DSP-13002

Application	General Data	
Project Name: Patriots Landing Location: On the eastern and western sides of Devitt Place between its intersections with Irvington Street to the south and Maury Avenue to the north, and on the northern and southern sides of Maury Avenue east and west of its intersection with Devitt Place. Applicant/Address: Marenberg Enterprises, Inc. 1143 West Lake Avenue Baltimore, MD 21210	Planning Board Hearing Date:	01/23/14
	Staff Report Date:	12/31/13
	Date Accepted:	10/21/13
	Planning Board Action Limit:	Waived
	Plan Acreage:	5.04
	Zone:	R-18
	Dwelling Units:	63
	Gross Floor Area:	N/A
	Planning Area:	76A
	Tier:	Developing
	Council District:	08
	Election District:	12
	Municipality:	N/A
200-Scale Base Map:	207SE01

SUBJECT: Detailed Site Plan DSP-13002
Patriots Landing

ELEVATIONS, 4-UNIT GROUP, 2-STORY

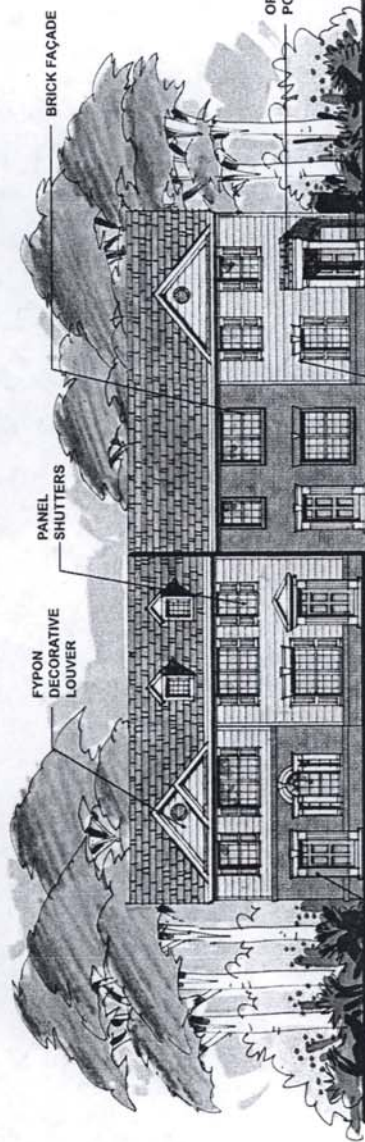
Comment: The models proposed for the subject project are attractively detailed mainly on the front façades. In recognition of the nature of the site as infill development and its proximity to surrounding residential dwellings, many of which feature complete or partial brick on their exterior façades, a proposed condition in the Recommendation section of this staff report would require that the applicant revise the architectural plans to clarify that the sides of most of the units should include brick on at least the first floor. With modifications as

ON-SITE METAL RETAINING WALL

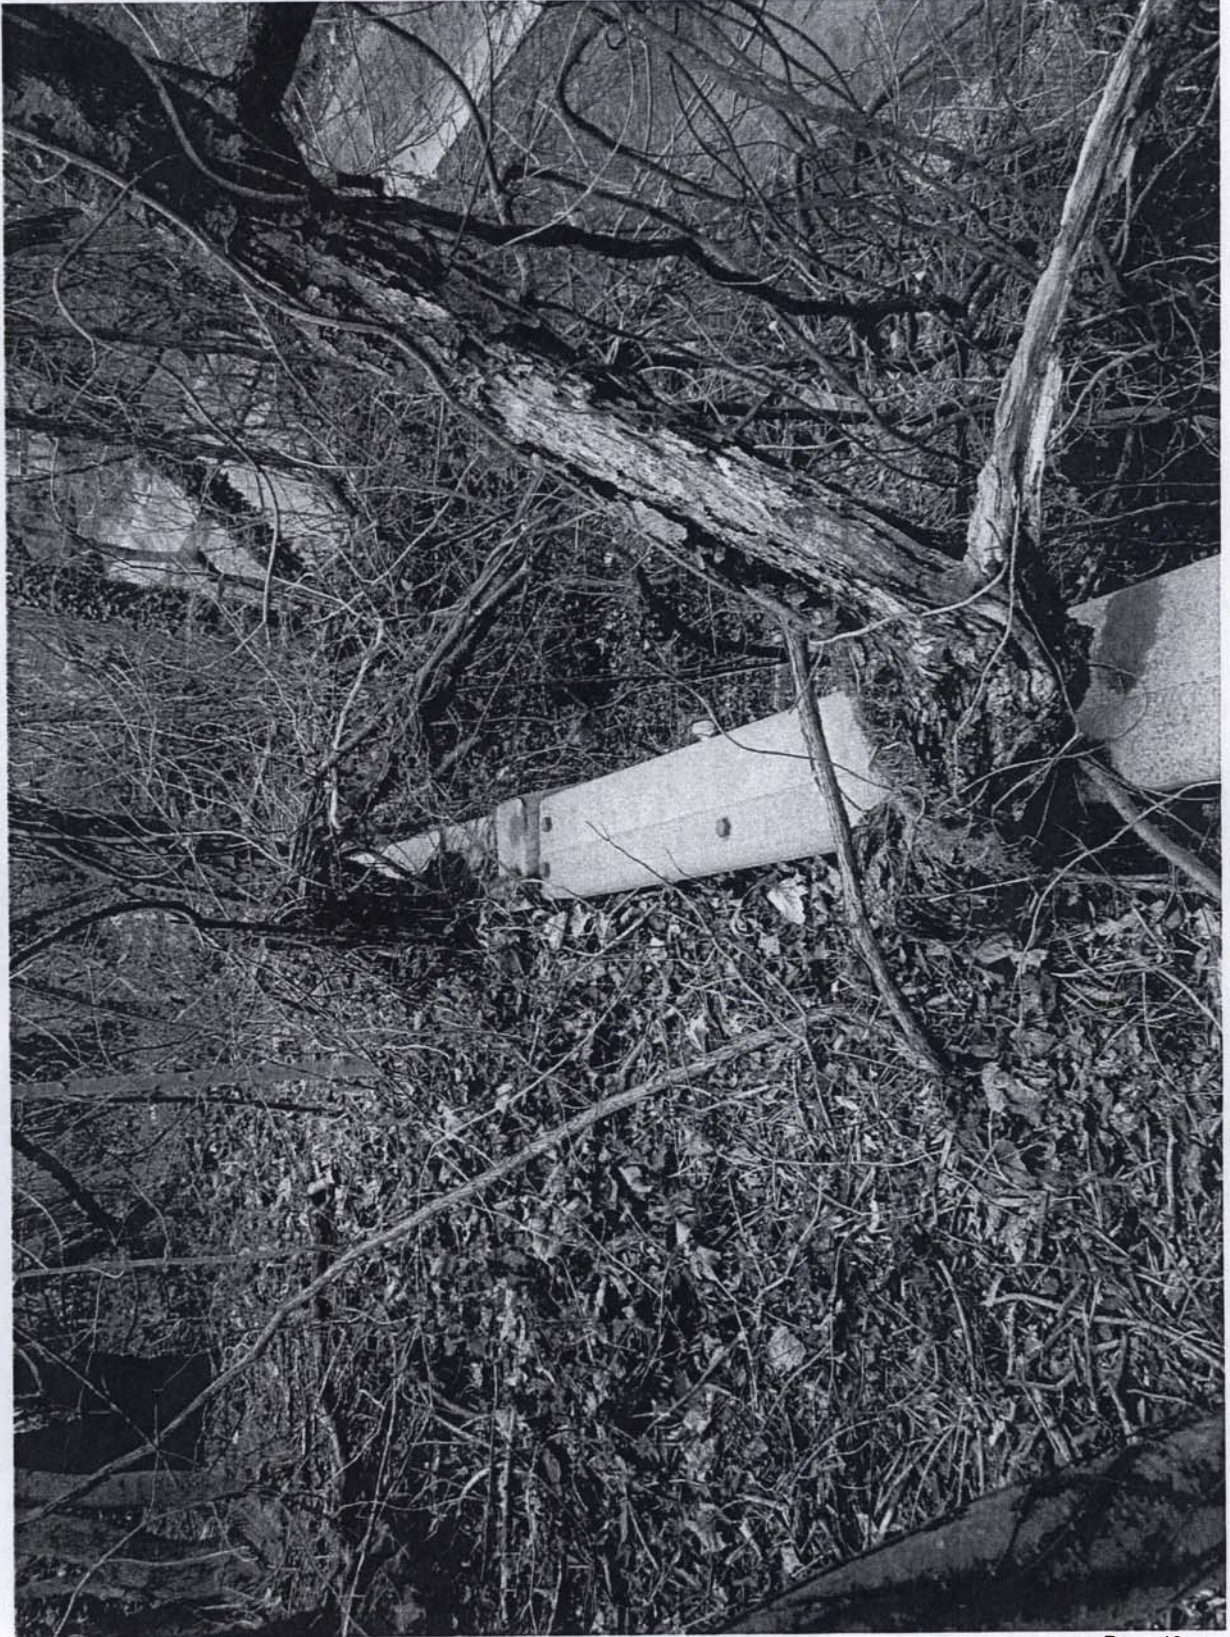
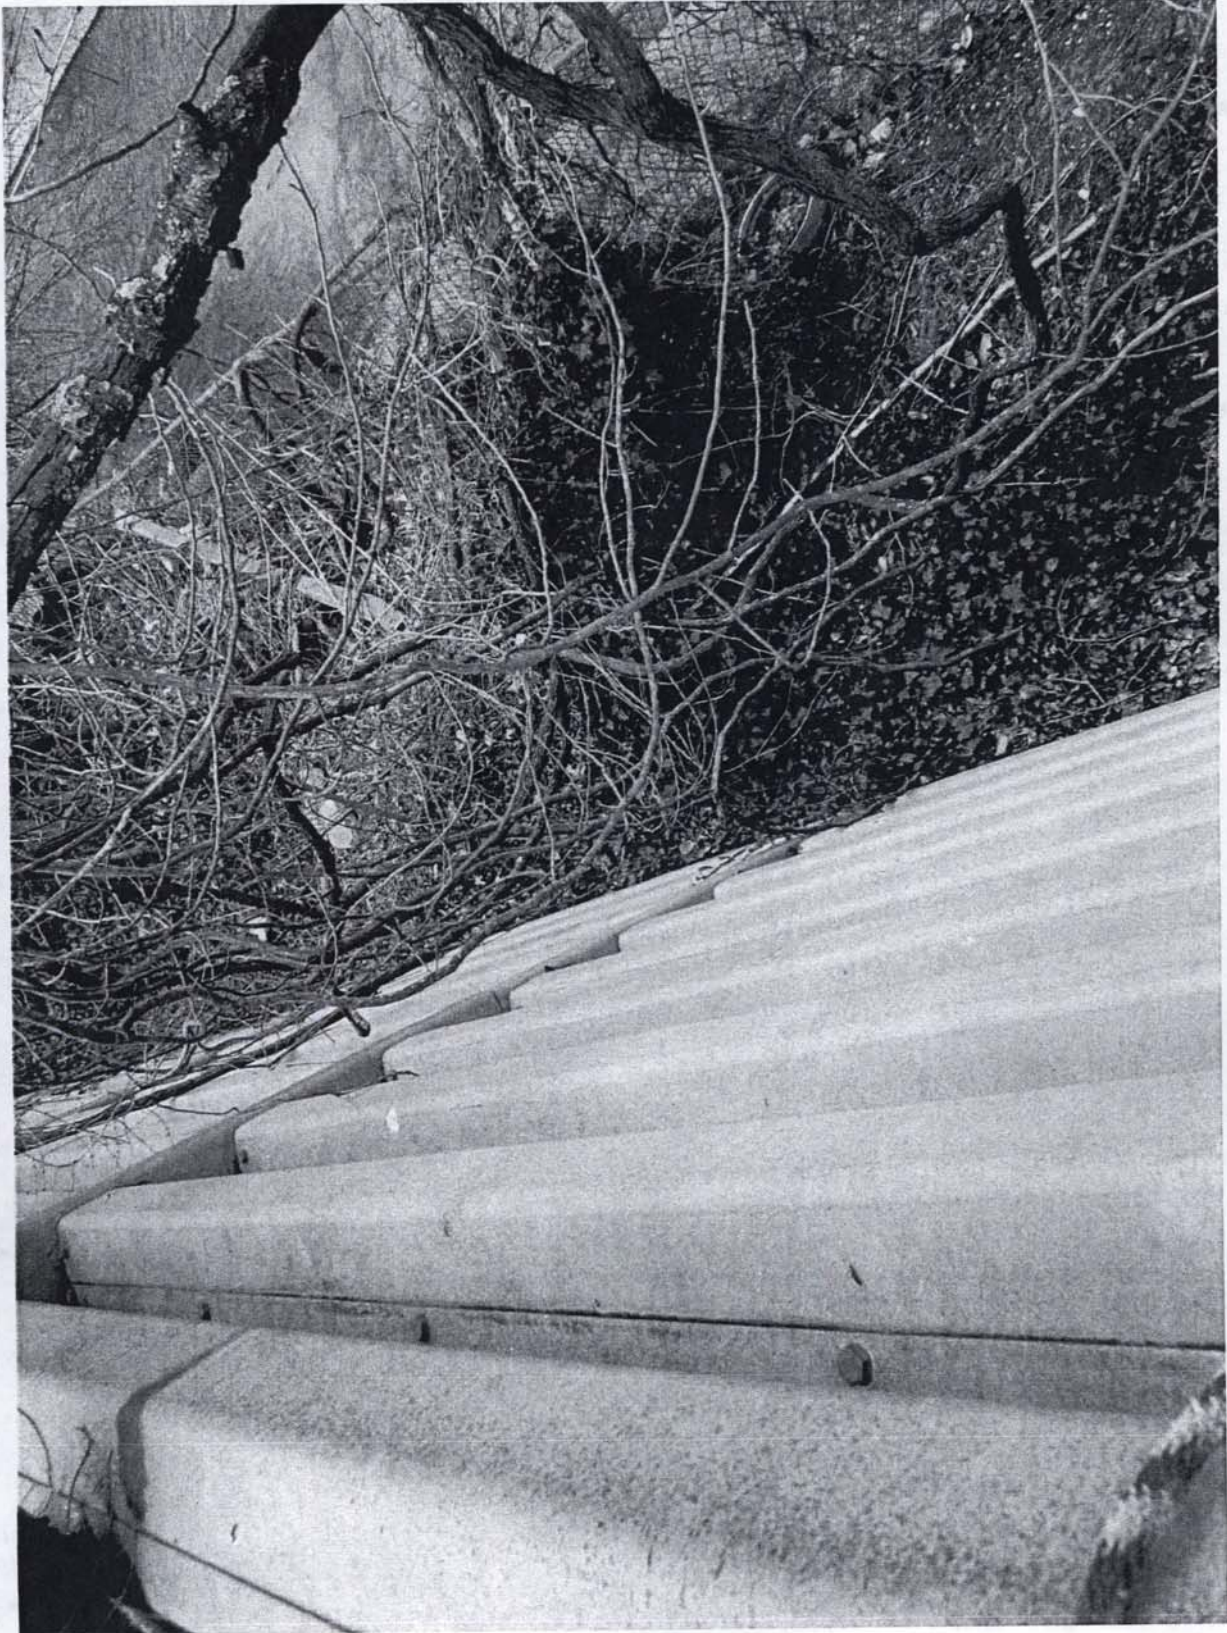
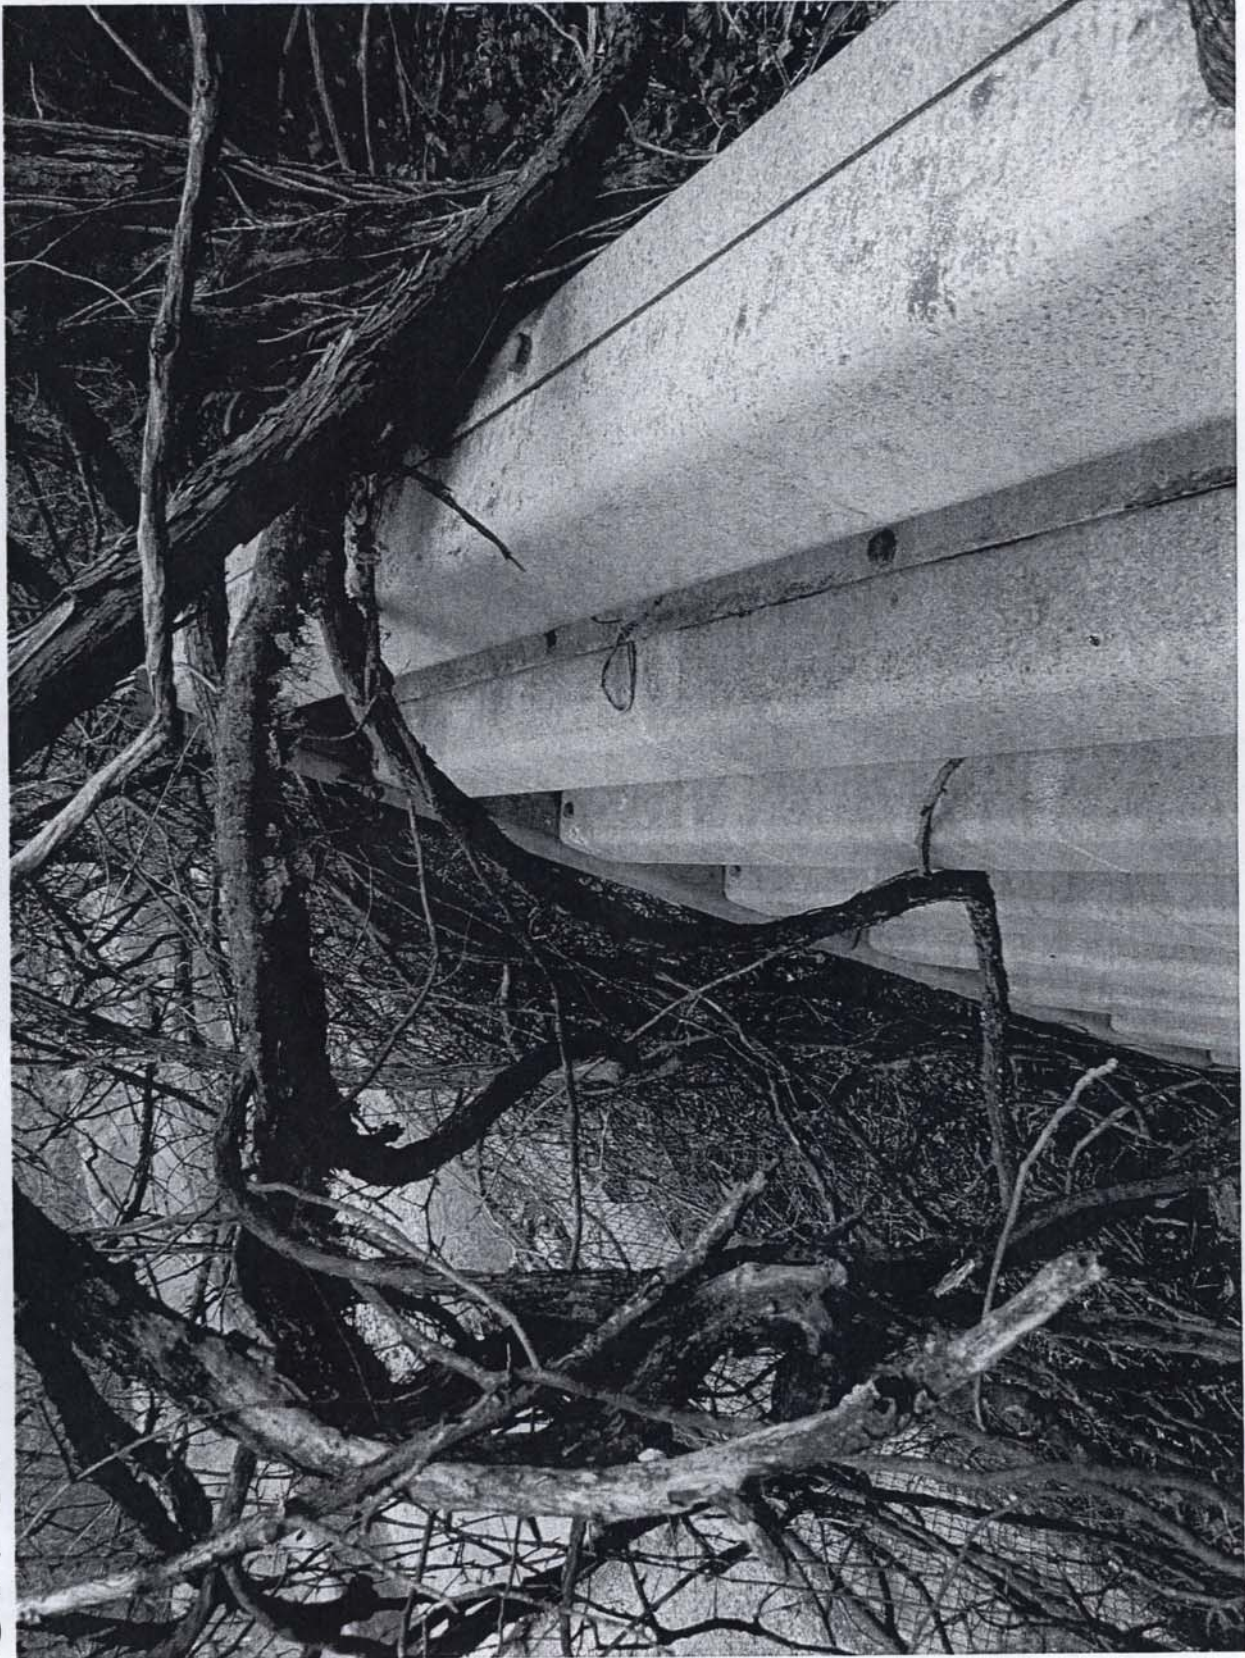
Comment: In a memorandum dated December 16, 2013, the Subdivision Review Section stated that the DSP labels the metal retaining wall on the northern property line of proposed Lots 48 and 49 as "to remain." As the retaining wall will be on the individual townhouse lots, its maintenance will become the responsibility of the homeowners. A condition below requires confirmation of the structural stability of this wall prior to issuance of the first building permit for the project.

- b. The metal retaining wall is structurally sound, or that it has been removed and its previous location has been graded out.
